STAFF REPORT: MARCH 13, 2025, REGULAR MEETING **PREPARED BY:** T. BOSCARINO & J. ROSS
APPLICATION NUMBER: HDC2025-00010
ADDRESS: 3500 MCDUGALL (A.K.A. 3100 GRATIOT AVENUE)
HISTORIC DISTRICT: PRINCE HALL GRAND LODGE
APPLICANT/ARCHITECT: KATIE COOK, KRAEMER DESIGN GROUP
PROPERTY OWNER: PRINCE HALL GRAND LODGE
DATE OF PROVISIONALLY COMPLETE APPLICATION: JANUARY 21, 2025
DATE OF STAFF SITE VISIT: FEBRUARY 28, 2025

SCOPE: REPLACE VINYL, STEEL, AND WOOD WINDOWS WITH ALUMINUM WINDOWS; INSTALL WALL SIGNS

Rear (southeast) elevation. Photo from application documents.

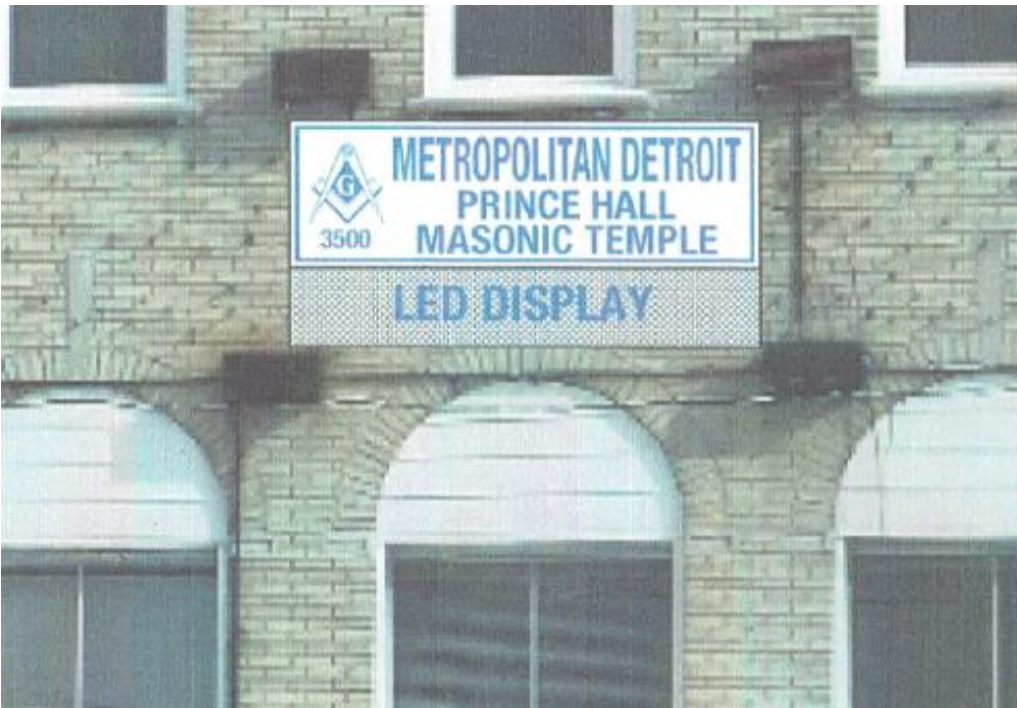
- Window units on the rear façade of the building, facing vacant property to the east, are hot-rolled steel 6- or 9-pane factory style units with a central, pivoting sash and wire glass. These windows appear to be original, but have rusted muntins, sashes, and frames, and degraded glazing compound. Note that a full documentation of each steel window proposed for replacement at this

location was not included in the current documentation, so it is unclear if all of the units are deteriorated to an extent that merits replacement. Also, the proposed new windows do not match the existing in operation or light configuration. Therefore, staff does not recommend approval of this scope item.

Uncredited 1920s photo provided by the applicant. A single bay of the 1924 building is visible at the far right edge of the photo. The two-story portion of the building shown was demolished when Gratiot Avenue was widened. However, note the location of signage as indicated by the red arrows.

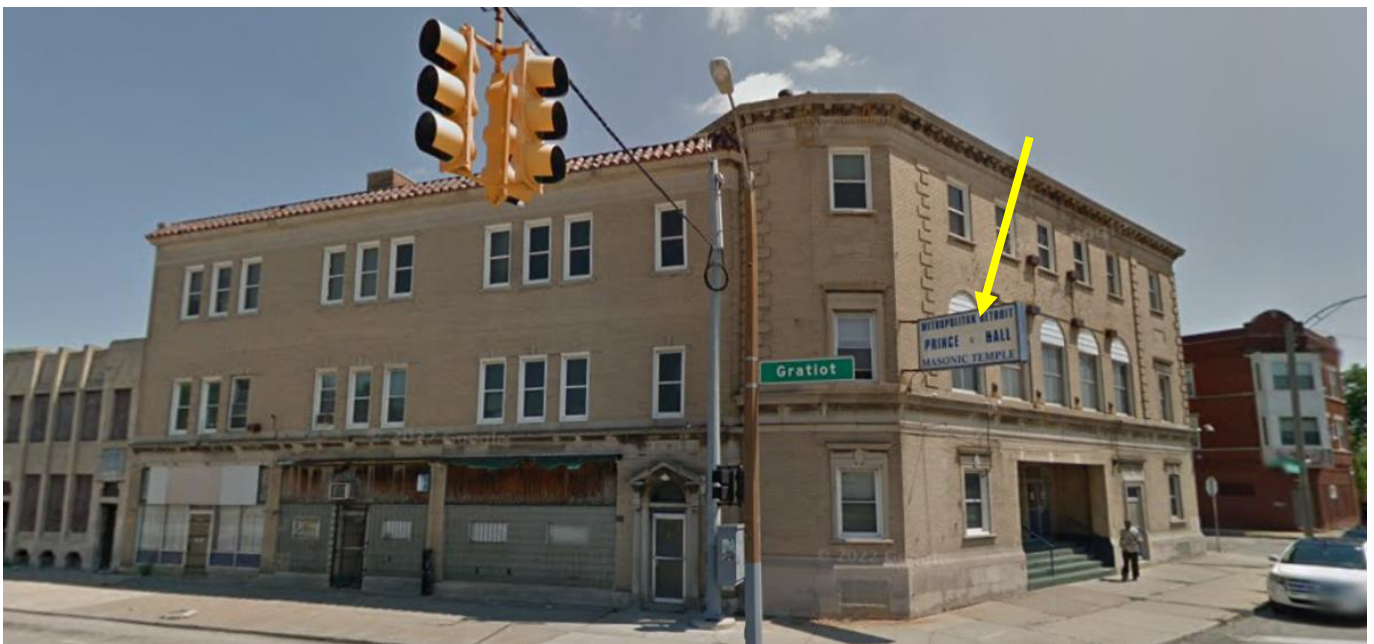
- Per the above provided historic photograph, signage was located in the masonry cornice, above the storefronts in the original Gratiot-facing wing. While this historic location suggests that new signage is best located at the masonry cornice above the first-story storefronts at the current Gratiot-facing façade, staff does recognize that the affixing of new signs to this distinctive architectural detail would not be appropriate.
